December 18, 2019

RE: **SAD 227 lot 4 Block 11, Volcano Cliffs Unit 5**
6301 Casa Blanca Dr. NW
Grading and Drainage Plan
Engineers Stamp Date 12/10/19 (E10D070)

TITLE: 6301 CASA BLANCA NW
GRADING & DRAINAGE PLAN

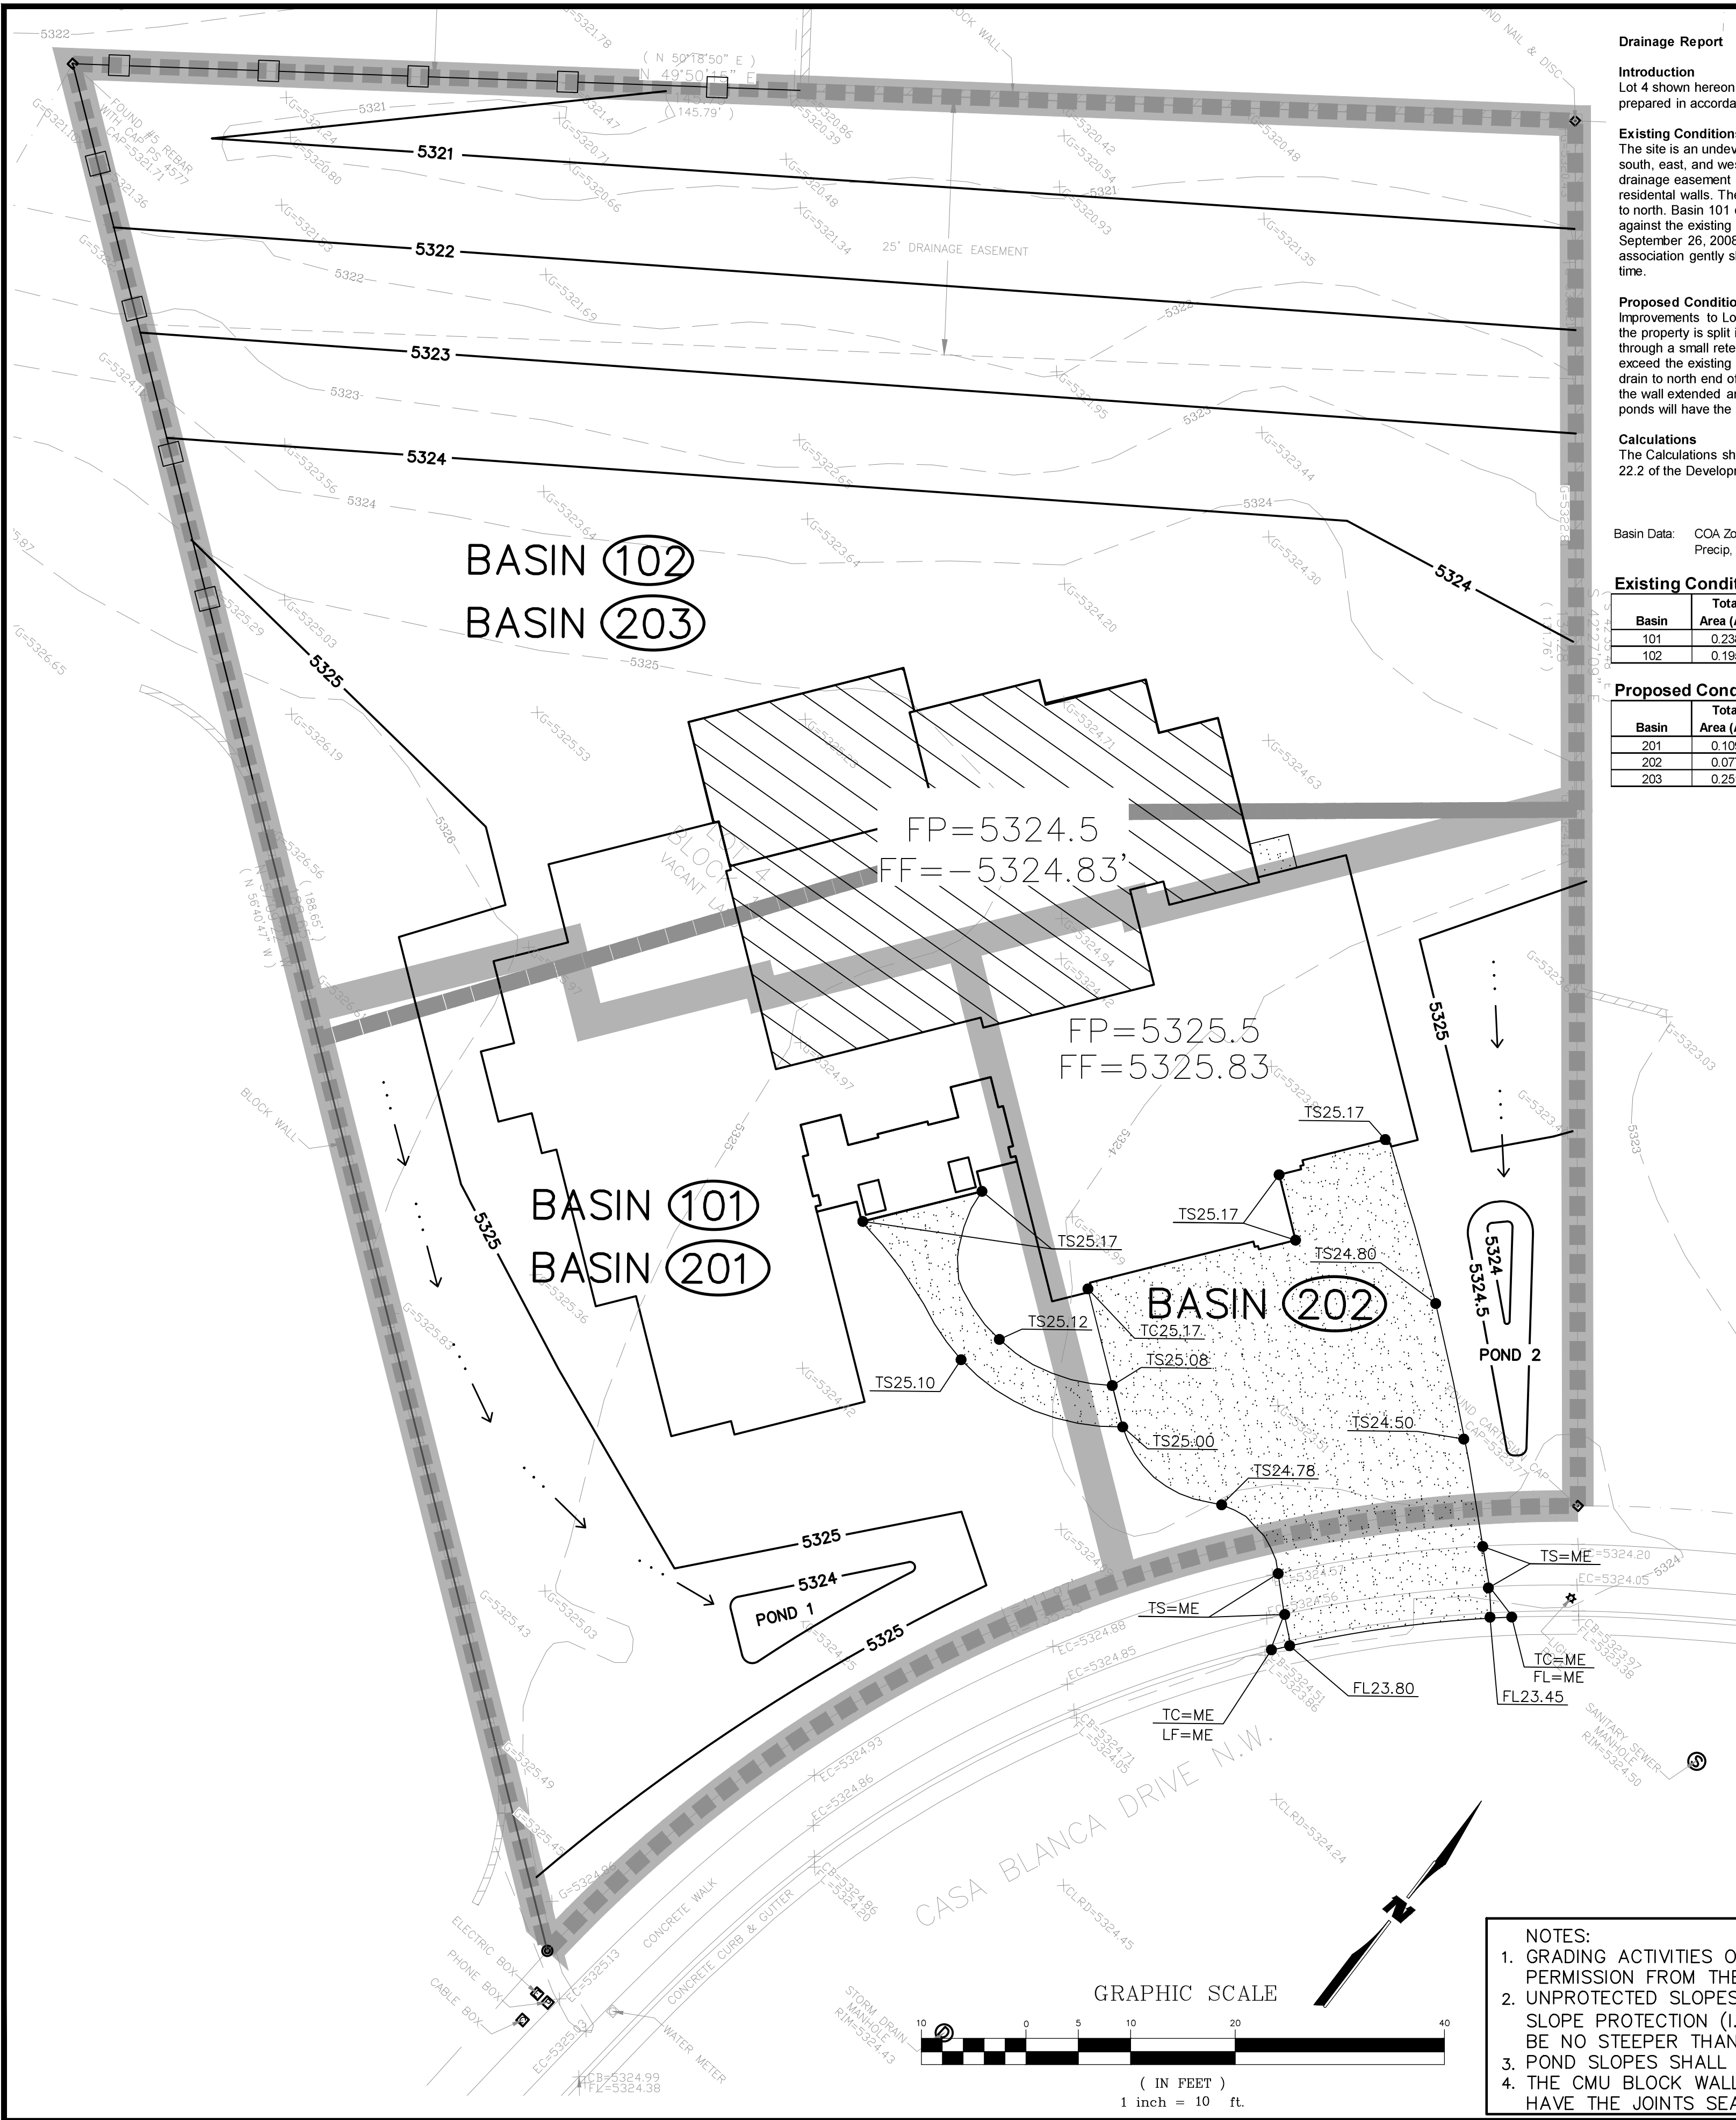
Based upon the information provided in your submittal received 12/10/19, this plan is approved for Grading Permit. Please attach a copy of this approved plan to the construction sets in the permitting process prior to sign-off by Hydrology.

Make sure the contractor and owner know not to use dirt as a ramp to climb the street curb, either use lumber or crusher fines for this purpose.

Prior to building Permit approval a pad certification is required.

Prior to Certificate of Occupancy release, Engineer Certification per the DPM checklist will be required.
